February 25, 1994
LD-94-016

Docket No. 52-002

Subject: System 80+™ Information for Issue Closure

The attachments to this letter provide material to close follow-on questions to DSER responses. Attachment 1 provides several minor revisions to Chapter 4 that resulted from a recent consistency review for that chapter. Based on our judgment and a discussion with Mr. L. Kopp of the NRC, it is our belief that none of these revisions affects the conclusions in the Advanced FSER. For example, changes to the fuel temperature correlation on page 4.3-13 were made to be consistent with the correlation that was actually used. Changes to Table 4.4-1 were faxed to Mr. S. Sun and transmitted separately in letter LD-94-015.

Figure
4.3-53

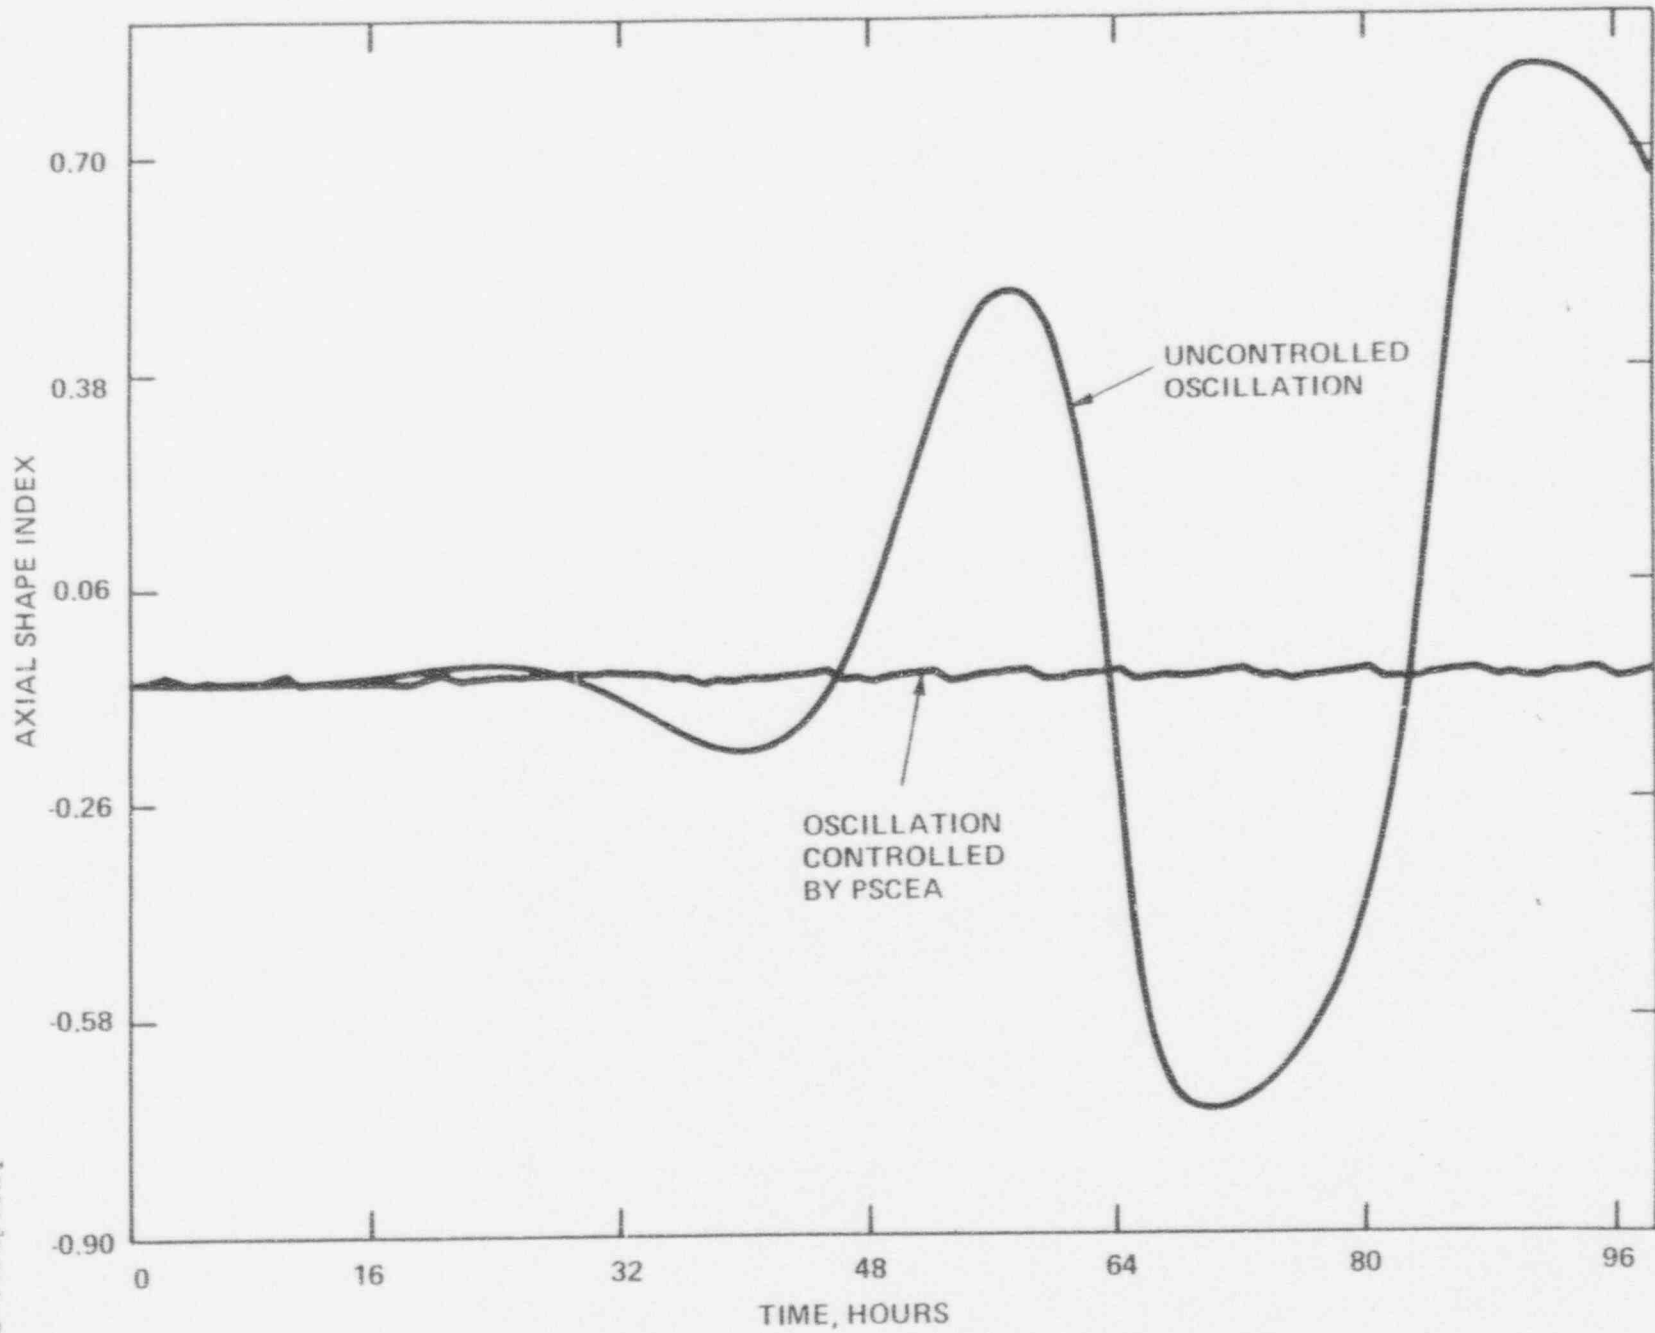
4.3-53	PSCEA-Controlled and Uncontrolled ^{Xenon} (Axial Xenon Induced Power) Oscillation
4.3-54	Rod Shadowing Effect vs Rod Position for Rod Insertion and Withdrawal Transient at Palisades

<p>TYPICAL TEMPERATURE DEFECT vs REACTOR INLET TEMPERATURE</p>	<p>Figure 4.3-58</p>
--	--	--------------------------

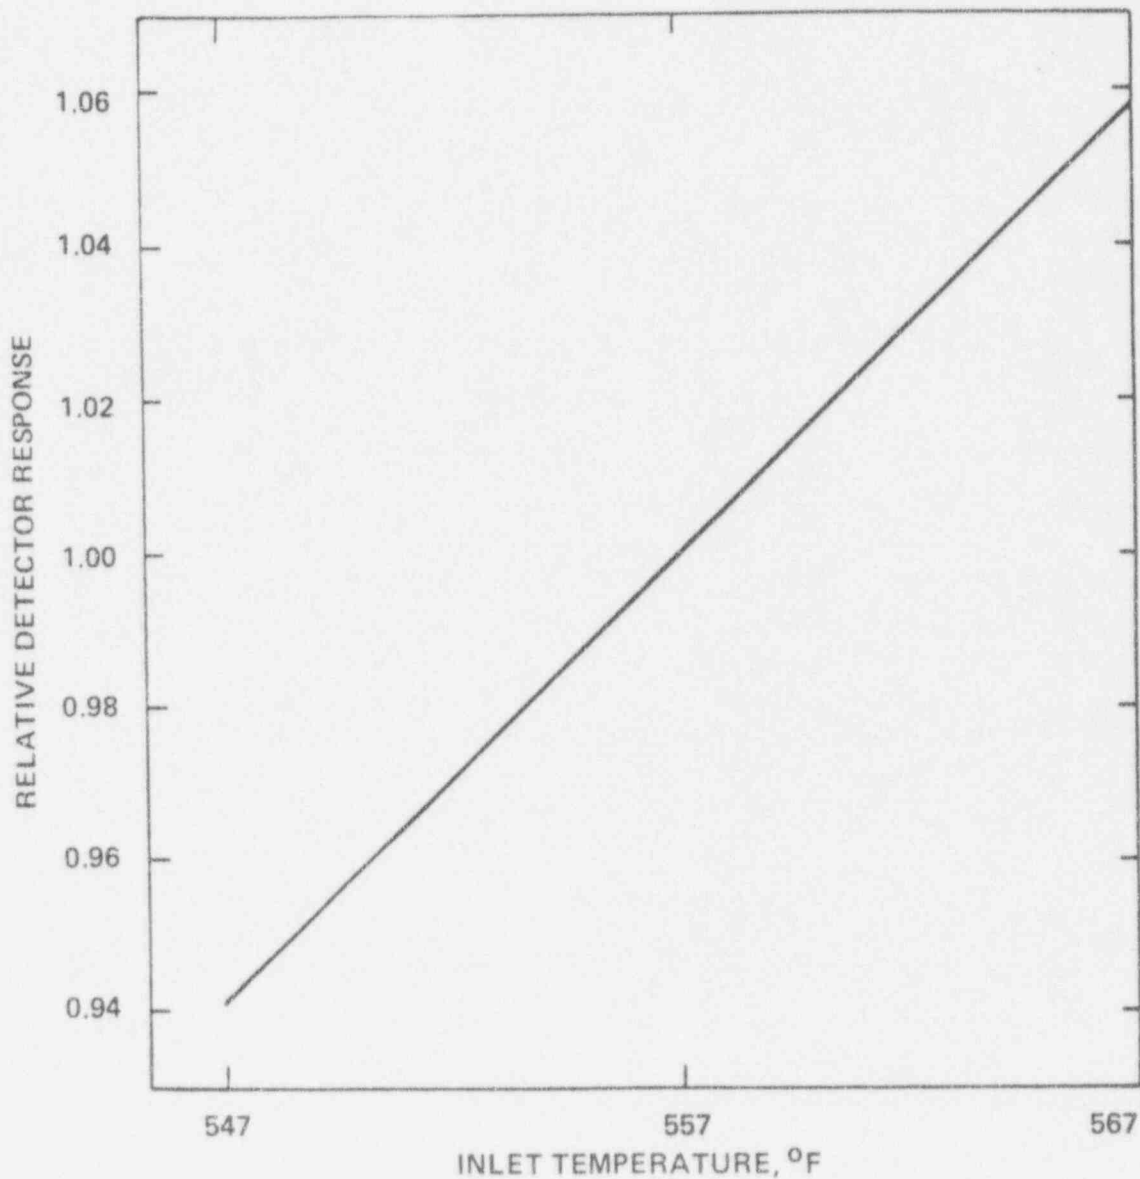
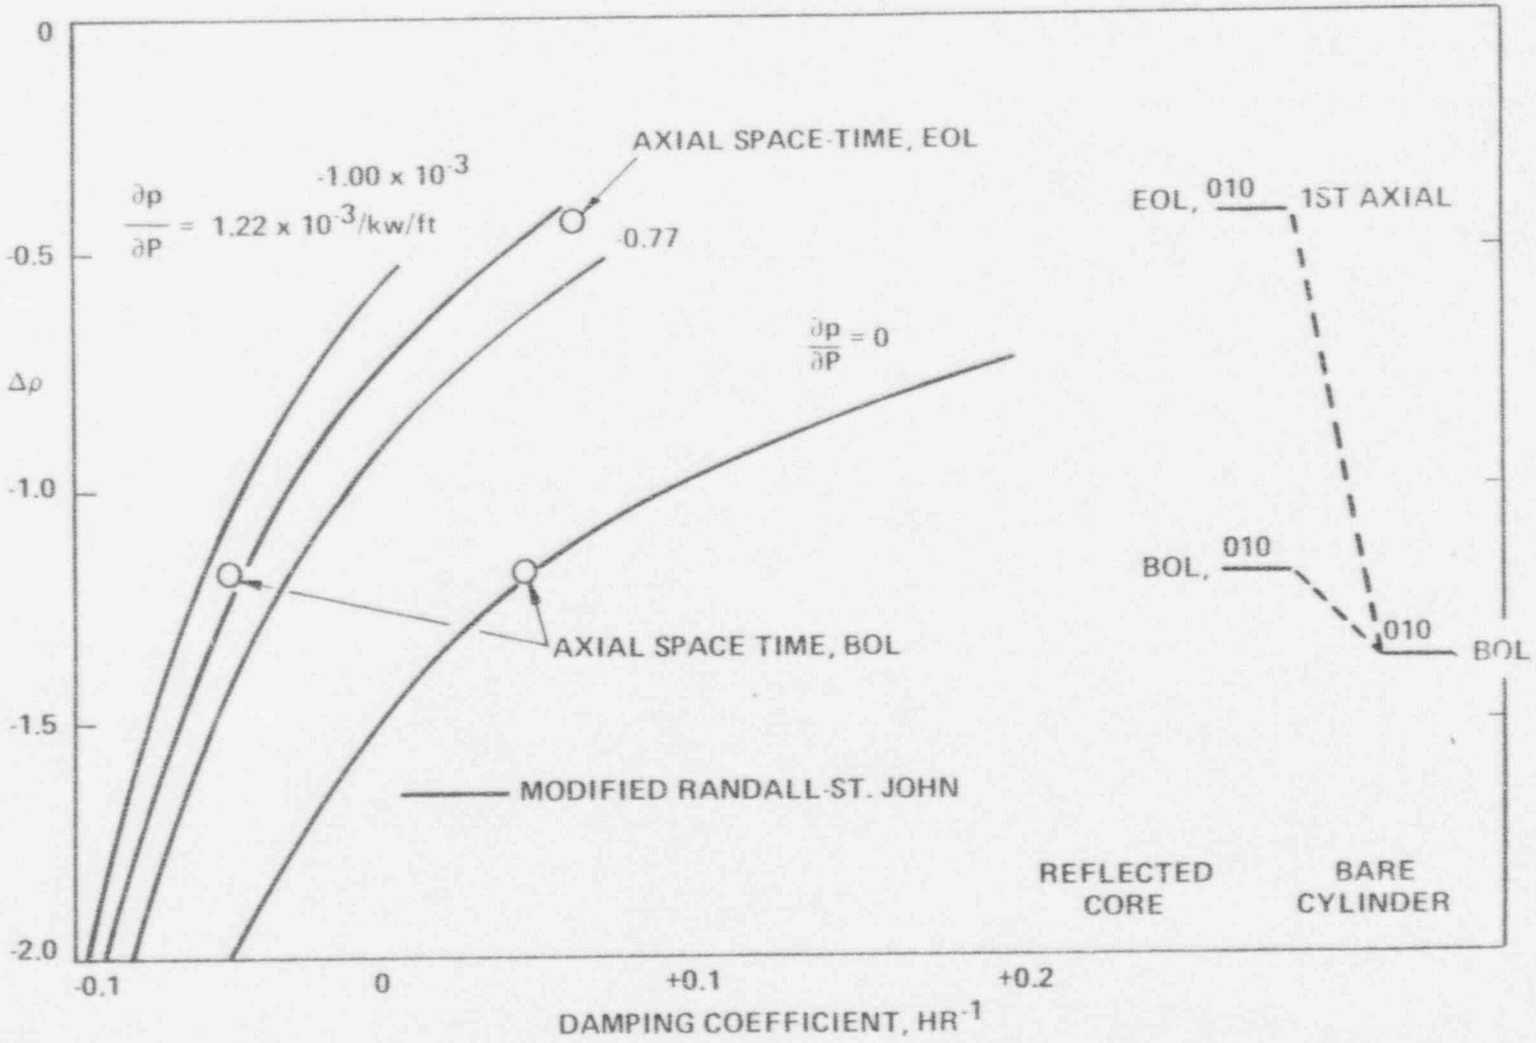
4.3-55	Typical Three Sub-Channel Annealing
4.3-56	Geometry Layout
4.3-57	Comparison of Measured and Calculated Shape Annealing Correlation for Palisades
4.3-58	Typical Temperature ^{Decalibration Effect} Defect vs Reactor Inlet Temperature

*DECALIBRATION
EFFECT*
